UNITED STATES PATENT AND TRADEMARK OFFICE

10/518,633

Office Action Summary	Application No. 10/518,633	Applicant(s) ARMER ET AL.	
	Examiner DNYANESH KASTURE	Art Unit 3746

DETAILED ACTION

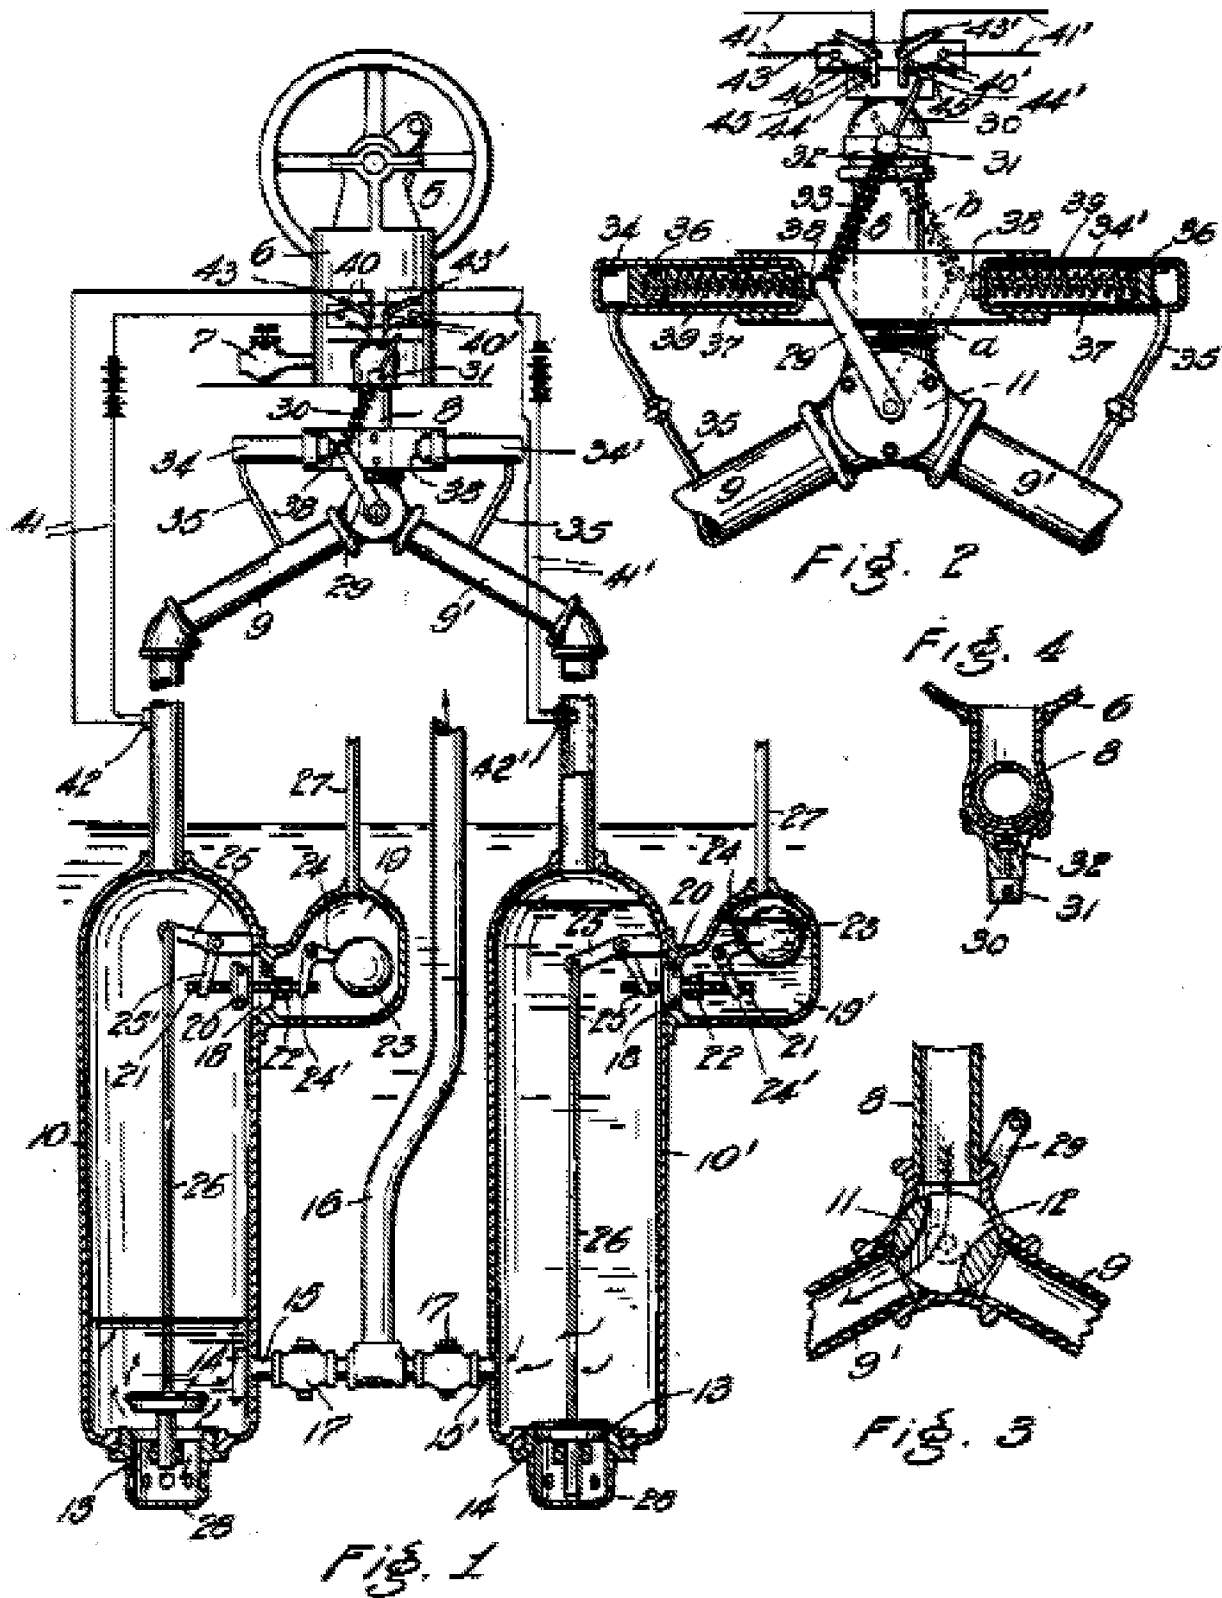
7. In Re claim 1, with reference to Figures 1-4 as depicted above, Emmons discloses a pumping apparatus described as:

- a first container (10) including a pressurisable chamber
- an inlet (13)
- an outlet (15)
- a control apparatus (21,22,23,24,25)
- second container (19)
- pilot valve (20)

- second container (19) receiving liquid from the first container (10) through passage (18) when the liquid in the first container (10) rises to a first pre-determined level which is the level of passage (18)

- the pilot valve (20) configured to open the passage (18) thereby triggering a depressurization cycle of the chamber of the first container in response to the liquid level in the FIRST container falling below a second predetermined level (lowest level of water in the main chamber) which moves the linkage (26) and (25) and triggers the depressurization. When the float (23) rises in response to the liquid in the second container (19), the closing of the valve (20) triggers a pressurization cycle for the motive fluid that enters through pipe (9). The motive fluid exits through pipe (27) during the depressurization cycle.

9. In Re claim 4, Emmons discloses the second container (19) which is relatively small compared to the first container (10) as depicted in Figure 1.

10. In Re claim 5, Emmons discloses the second container (19) whose base is at a relatively higher location than the base of the first container (10) as shown in Figure 1.

- the apparatus is arranged so that when one pump is discharging fluid, the other is receiving fluid, as depicted in Figure 1.

14. In Re claim 12, Emmons discloses a valve (14) in each first container of the two pumps at the inlet. As depicted in Figure 1, the valves are arranged so that when one pump is charging, the other is discharging.
